SOILS AND GEOLOGY STUDY

**Winslow Drive
Estates at Cathedral Pines
El Paso County, Colorado**

JOB NO. 187749

June 24, 2022

FIG No. 4
pg. 1 of 2

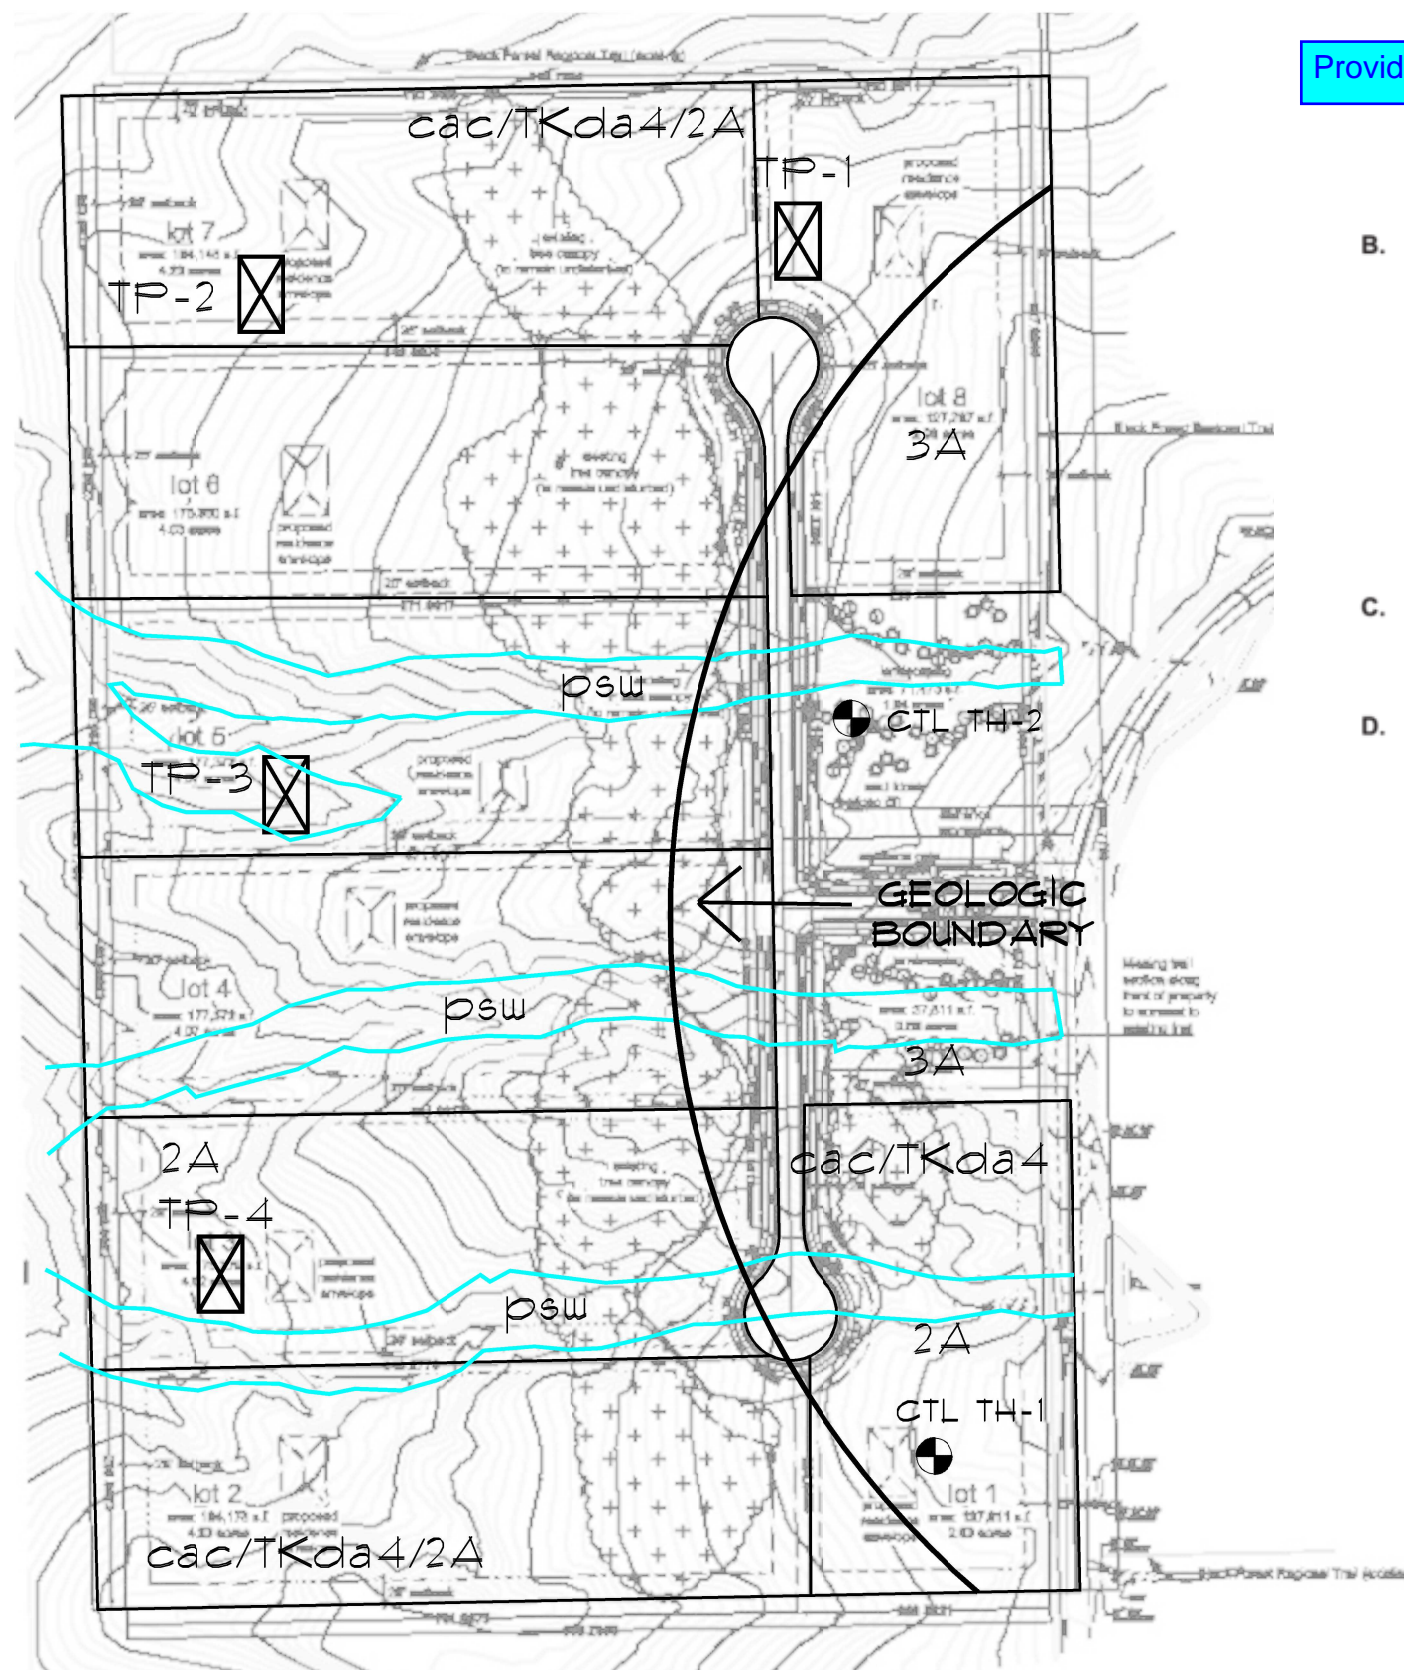
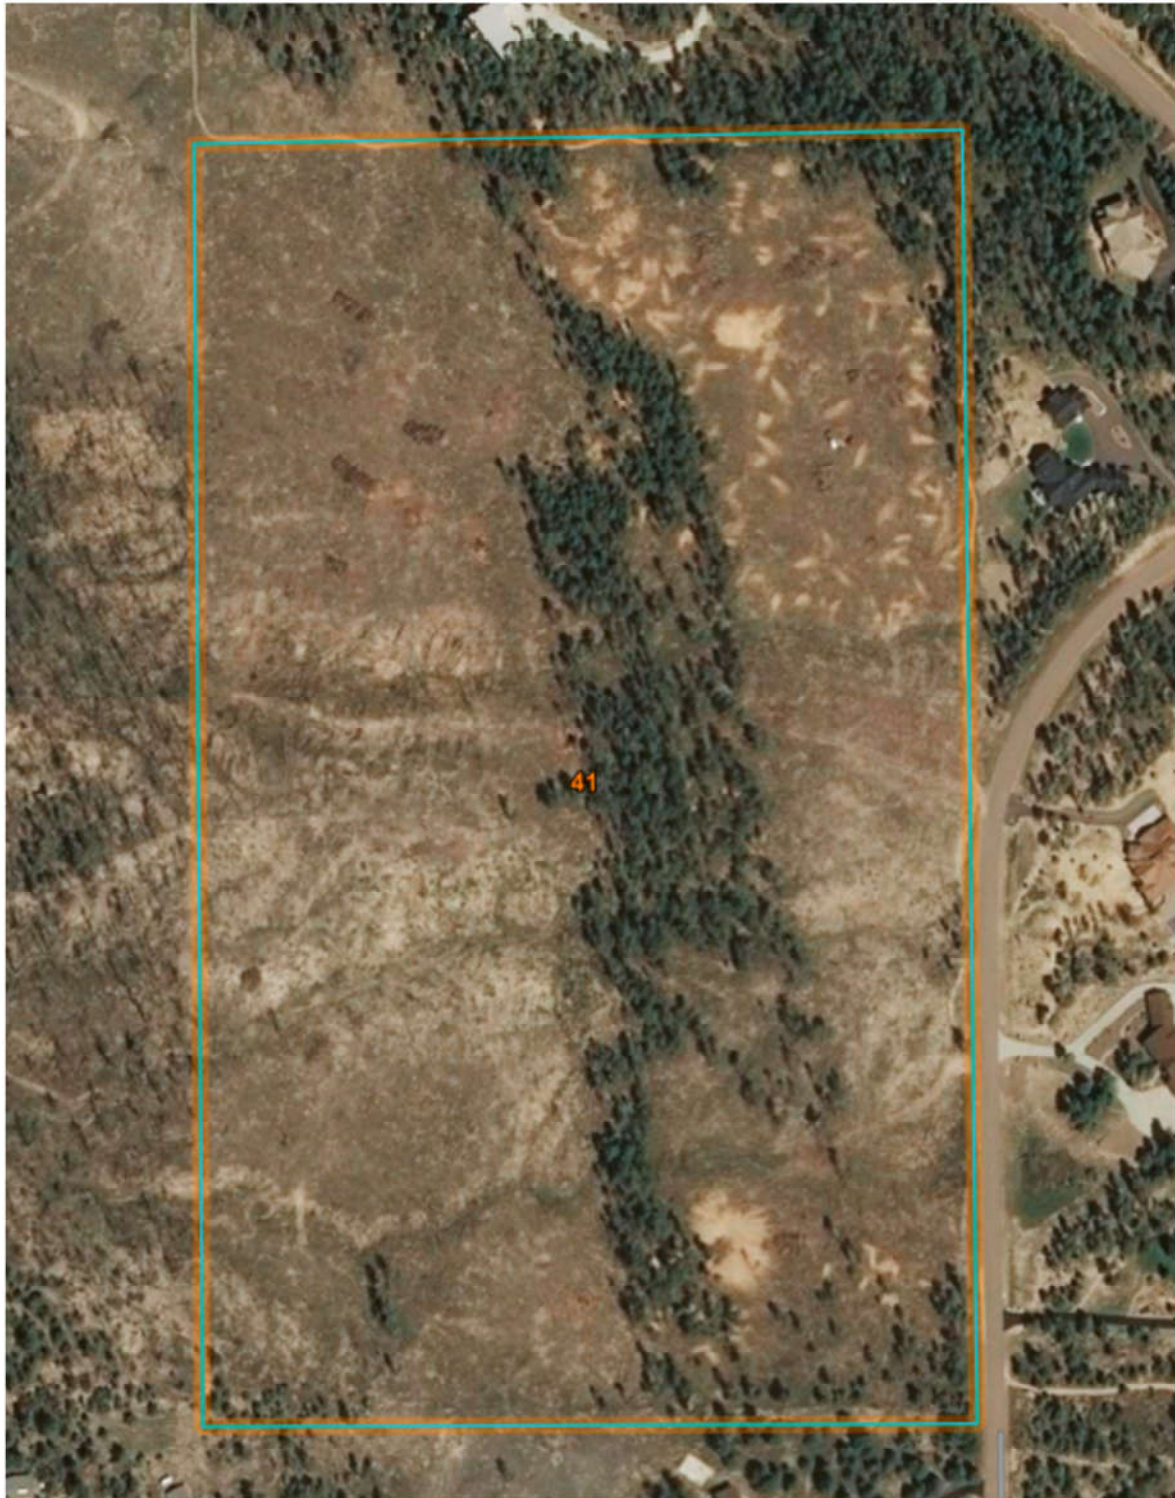
Provide borings per ECM C.3.3.B. and C.3.3.D

B. Frequency of Borings.
The following represent the minimum number of borings that are required based on a typical improvements project. The number of borings may be increased based on the geotechnical engineer's recommendations or at the request of the ECM Administrator.

- A minimum of 2 borings for each project with public improvements shall be performed.
- A minimum 1 boring for each SCS (NRCS) soil type within a development shall be performed.
- A minimum of 1 boring shall be performed for each 10 acres of development up to 100 acres. One additional boring shall be performed for every 25 acres of development above the 100 acres.

C. Borings for Structures.
The boring frequency for transportation structures shall satisfy AASHTO Bridge Design requirements and CDOT Materials Testing requirements.

D. Depth of Borings.
Borings shall be performed to a minimum depth of 20 feet. In areas where the cut depths are expected to exceed 8 feet, borings shall be extended to a minimum of 15 feet below proposed finished grade. Borings shall extend deeper if needed to determine if bedrock or high groundwater levels are design concerns. Samples for structures shall be taken to a minimum depth of 10 feet below the footing elevation. Additional depth may be required for piers or piles.
